# E8363B-07A

## S E R V I C E N O T E

### E8363B PNA Series RF Network Analyzers

**Add-on mechanical components to enhance instrument reliability.**  
*This optional modification is chargeable to customer warranty only if done concurrently with other instrument repairs in an Agilent service facility.*

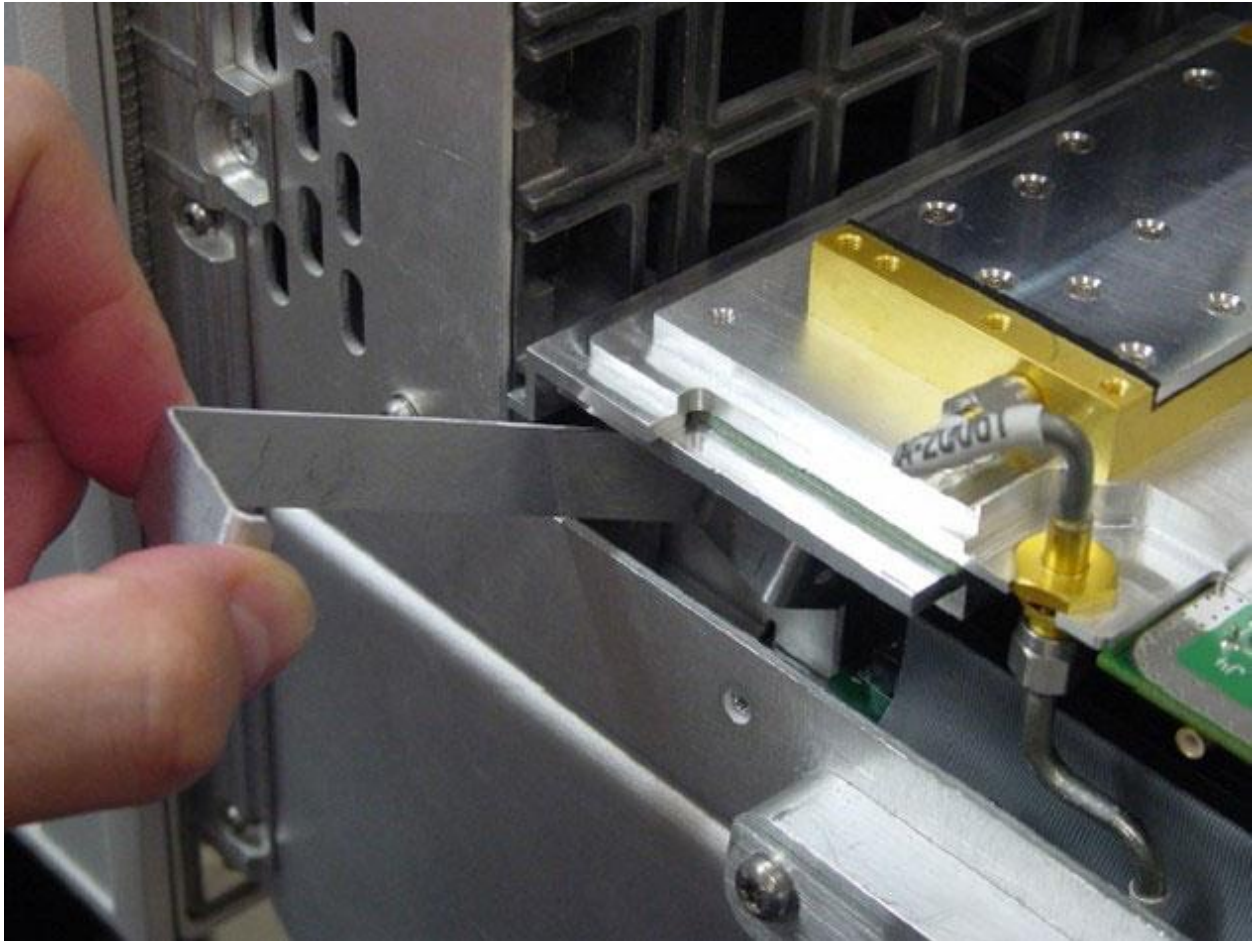
- a. Remove and discard existing screw near ribbon cable connector on System Motherboard. See below.

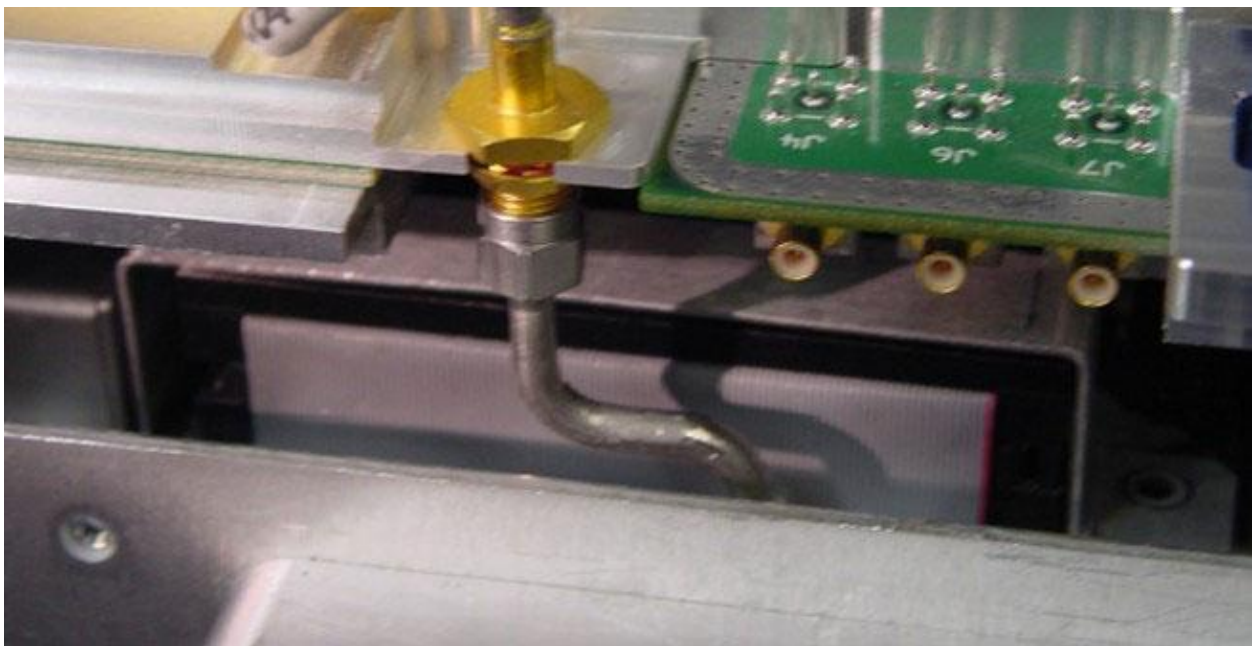
- b. Insert Ribbon Cable Clamp under Source Assembly as shown.

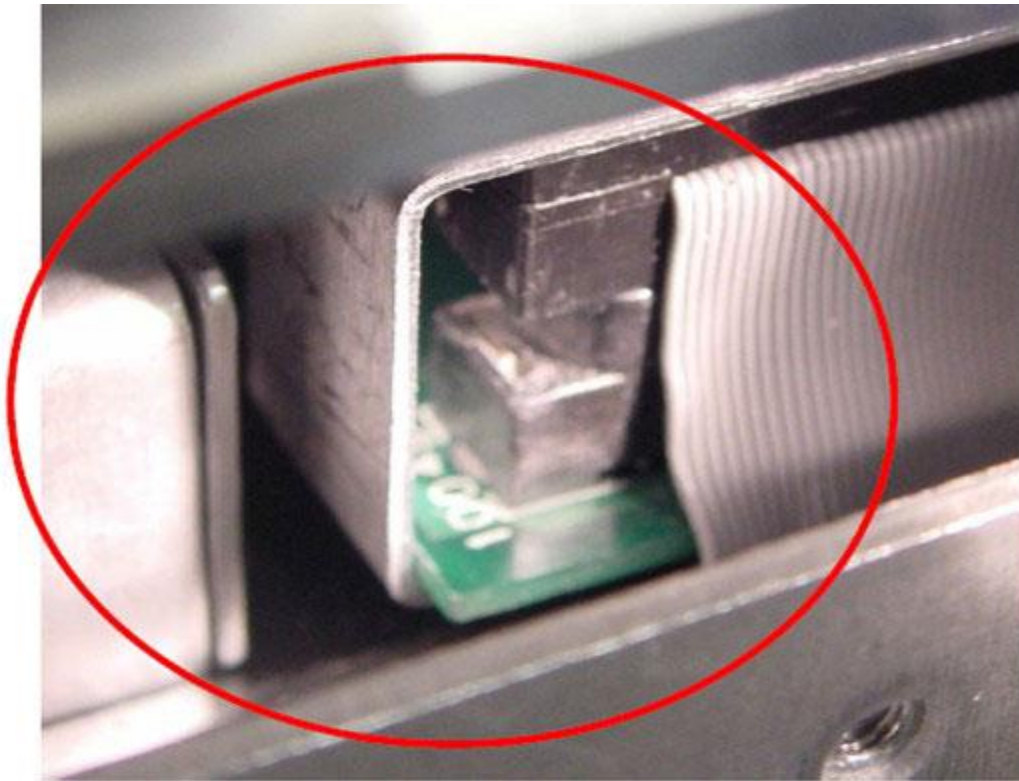
- c. Position the clamp over the Ribbon Connector. Use needle nose pliers if necessary to slide the clamp into place. Ensure that the edge of the clamp is parallel to the connector and not skewed.

**NOTE: Ensure that the Clamp Lip is secured BELOW the edge of the System Motherboard**

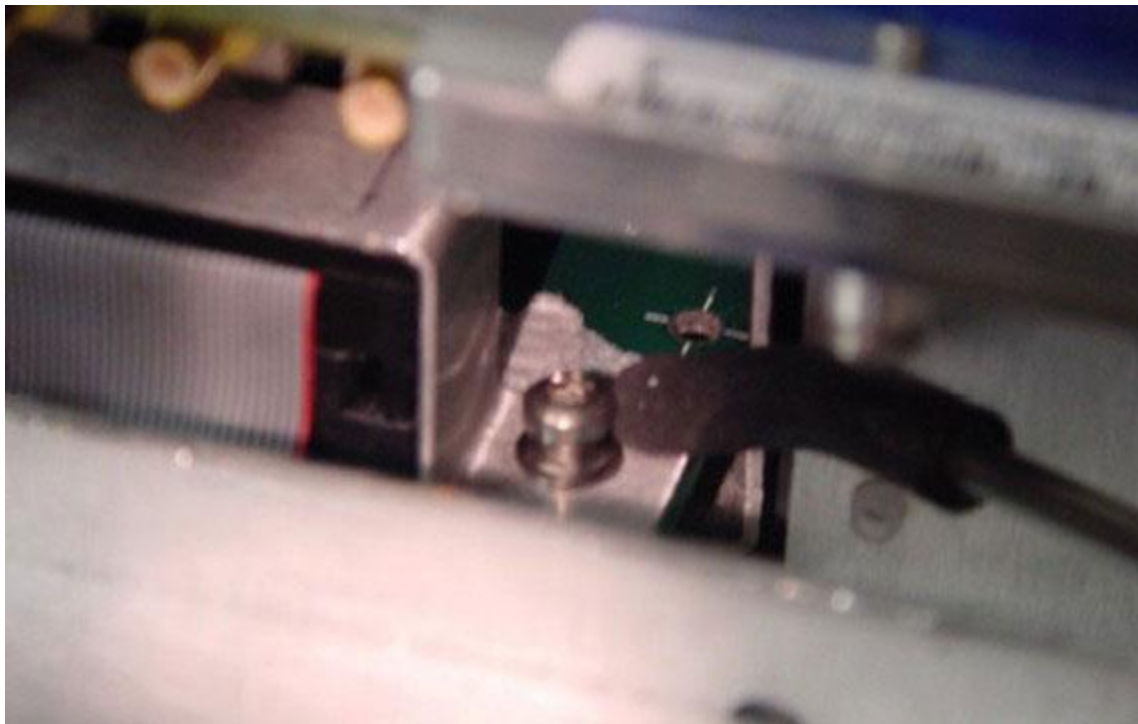
- d. Using tweezers, install a new 0515-0374 screw through the hole in the bracket.

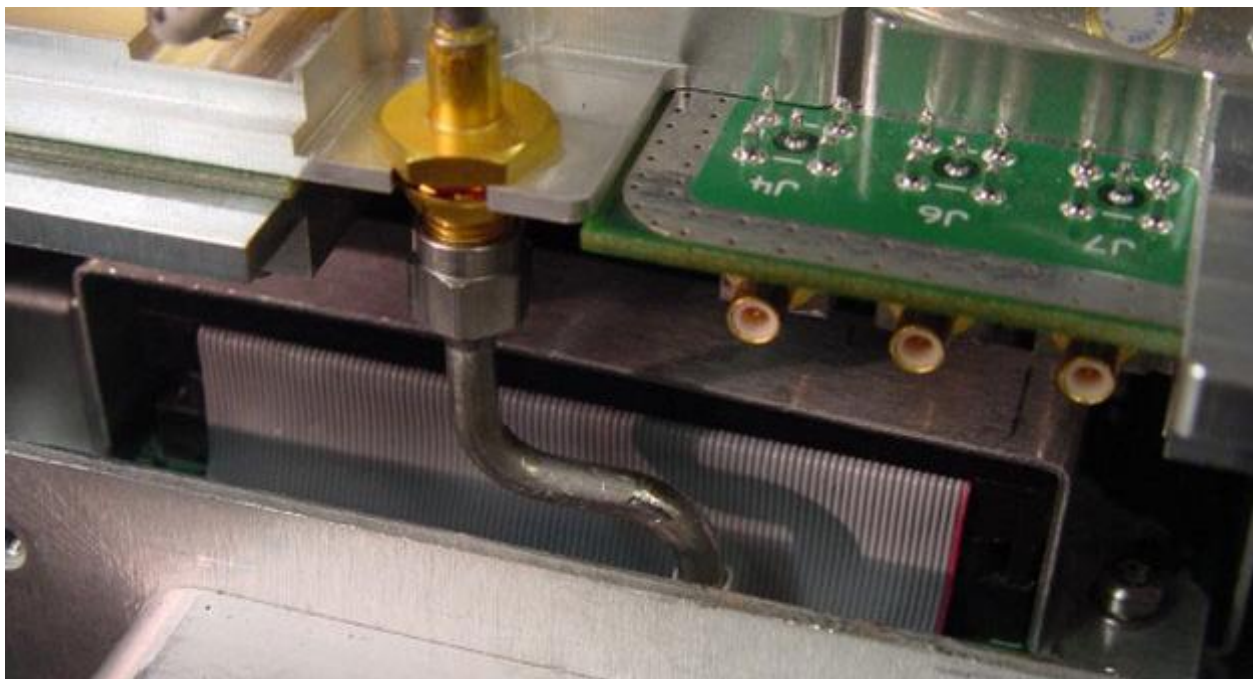
- f. Secure screw using the modified 10 lb-in breakaway wrench.

g. This image shows the final position of the secured clamp.

Figure 2a

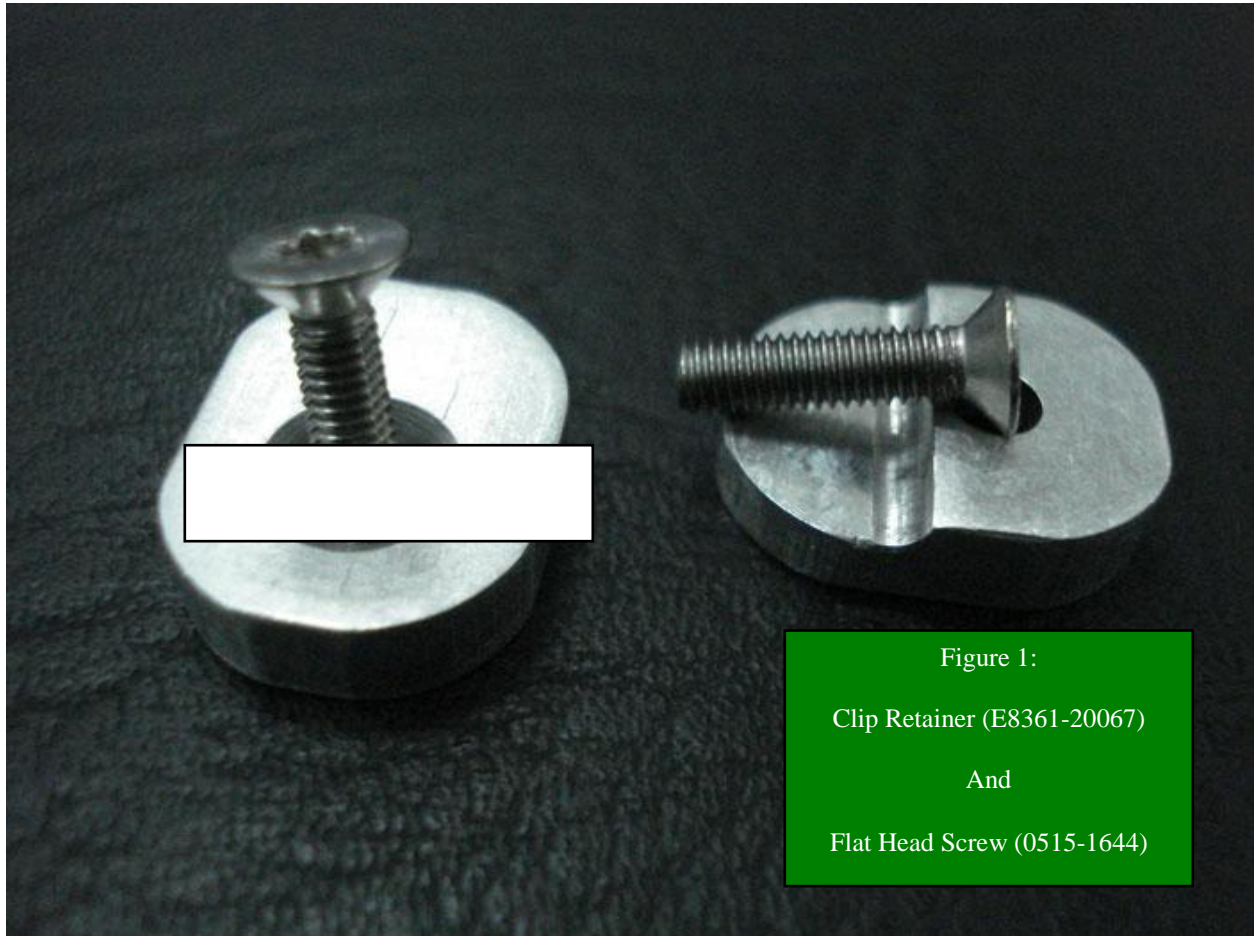
The Clip Retainer (E8361-20067) to be secured with Flat Head screw (0515-1644) in 2 places at 9 lb-in. This Retainer Clip may naturally rotate a bit when being secured, which is acceptable. Note that the existing screw needs to be removed and discarded prior installing Retainer Clip #1 (shown below in Figure 2a, 2b, and 3).

Figure 2

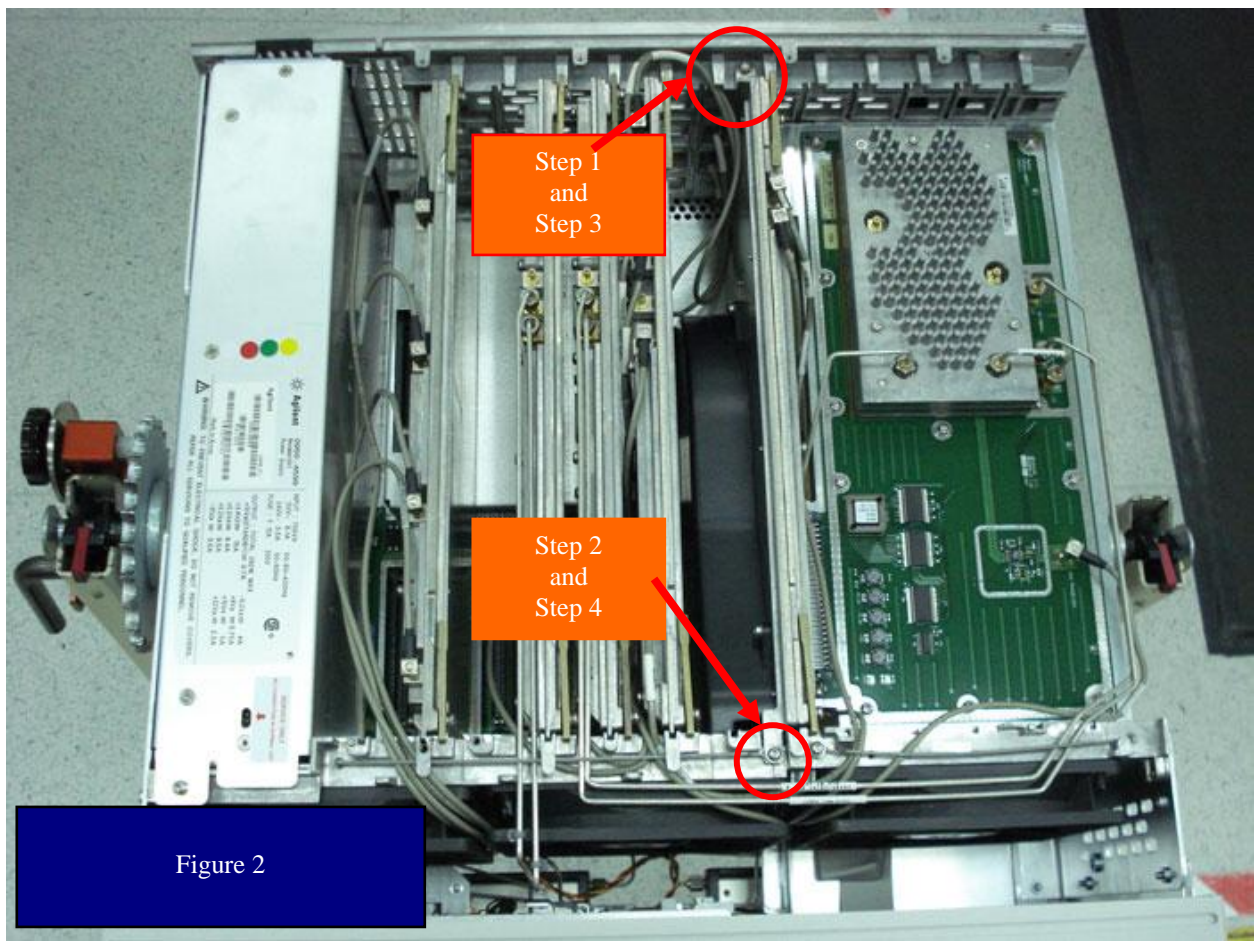
The Patch-Lock Screw (0515-2799) and Flat Washer (3050-0891) to be used in 2 places and secured at 9 lb-in. These parts will replace existing screw (0515-0374) used in Step 3 and Step 4 (as shown in Figure 2) to secure the Phase Lock Board (E8364-60137).
